EXTRAORDINARY COUNCIL MEETING

5.1.1 DEVELOPMENT APPLICATION - 62/2021 GUNDAGAI PRESCHOOL REDEVELOPMENT, FIRST AVENUE, GUNDAGAI

DOCUMENT NUMBER	350101
REPORTING OFFICER	Sharon Langman, Manager Development, Building and Compliance
AUTHORISING OFFICER	Phillip McMurray, General Manager
RELEVANCE TO COMMUNITY STRATEGIC PLAN	3. Sustainable natural and built environments: we connect with the places and spaces around us 3.2 Our built environments support and enhance liveability
FINANCIAL IMPLICATIONS	There are no financial implications associated with this report.
LEGISLATIVE IMPLICATIONS	Council needs to assess each application on its individual merits in accordance with legislative requirements and timeframe.
POLICY IMPLICATIONS	There are no policy implications associated with this report.
ATTACHMENTS	1. Assessment Report DA 62-2021 Gundagai Preschool ↓

Figure 10 - Overland flow mapping

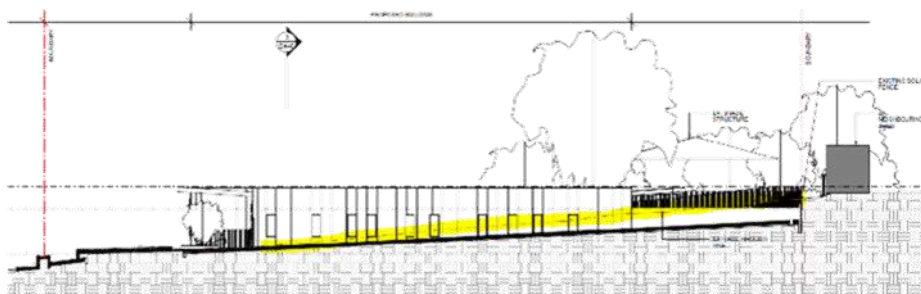
The site is not affected by the 1% AEP for mainstream flooding, as shown in the 2018 Flood Study, but is partially affected by overland flow (see flood contours on adjacent figure). What this shows, when compared to the levels shown on the site plan, is that between approximately 100 mm and 400 mm of water flows across the site, at various locations. A draft stormwater management plan has been lodged that indicatively shows how stormwater will be collected, managed and discharged. The plan includes a series of stormwater inlet pits throughout the carpark, the outdoor play area and the front yard area, to intercept surface waters/overland flow, prior to discharging to Council’s stormwater system. Council’s Engineers have raised concerns with regards to pipe size, surcharging of water onto the footpath and connection to Council’s stormwater system. Accordingly, the size of the pits and pipes will need to be assessed as part of the construction certificate phase, to ensure that they are adequate to manage the stormwater. Provided this infrastructure is sized correctly, the development should not adversely affect flood behaviour and is not likely to adversely affect the environment. It is considered that the site is compatible with the flood hazard and incorporates appropriate measures to manage risk to life from overland flow (see also earthworks section below).
